Access Compliance Report

Public Rights-of-Way

(Curb Ramps)

Intersection ID: 28276	Main Street: LONG_COVE_DR	Cross Street: TOM_SHORT_RD	Location: NW
ADA ID: 617696E3D488	Ramp Type: PerpDiag	Initial Pass/Fail: Fail	Overall Compliance: No
		Severity Score: 12.5

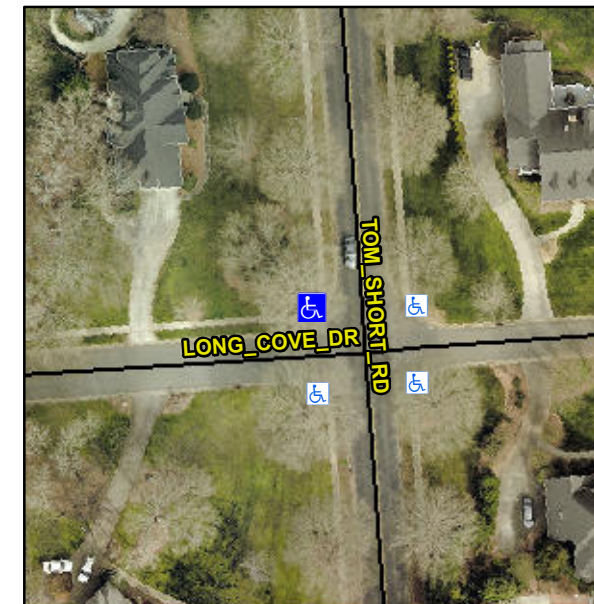
R304.2.2

Compliance	Description	Data	Compliance	Description	Data
N/A	Ramp Length (in)	57.0	No	Ramp Slope (%)	11.6
Yes	Ramp Width (in)	48.0	Yes	Ramp XSlope (%)	0.2
N/A	Flare Type LT	N/A	N/A	Flare Type RT	N/A
N/A	Flare Slope LT (%)	N/A	N/A	Flare Slope RT (%)	N/A
N/A	Flare Traversable LT?	N/A	N/A	Flare Traversable RT?	N/A
N/A	Landing Length (in)	N/A	N/A	DWS Provided?	N/A
N/A	Landing Width (in)	N/A	N/A	DWS Contrast?	N/A
N/A	Landing Slope (%)	N/A	N/A	DWS Length (in)	N/A
N/A	Landing X Slope (%)	N/A	N/A	DWS Full Width?	N/A
N/A	Landing Curb? (Y/N)	N/A	N/A	DWS Offset (in)	N/A
N/A	Shared Landing?	N/A			
N/A	Gutter Ponding?	N/A	N/A	Gutter Slope (%)	N/A
N/A	Gutter Lip Ht (in)	N/A	N/A	Gutter X Slope (%)	N/A
N/A	Painted X Walk1?	No	N/A	Painted X Walk2?	No
	X Walk 1 Direction	To S		X Walk 2 Direction	To E
N/A	X Walk 1 Width (in)	N/A	N/A	X Walk 2 Width (in)	N/A
	X Walk 1 Slope (%)	1.7		X Walk 2 Slope (%)	0.2
	X Walk 1 X Slope (%)	0.8		X Walk 2 X Slope (%)	1.7

Remove & Replace Curb Ramp With Two New Directional Ramps or Equivalent.
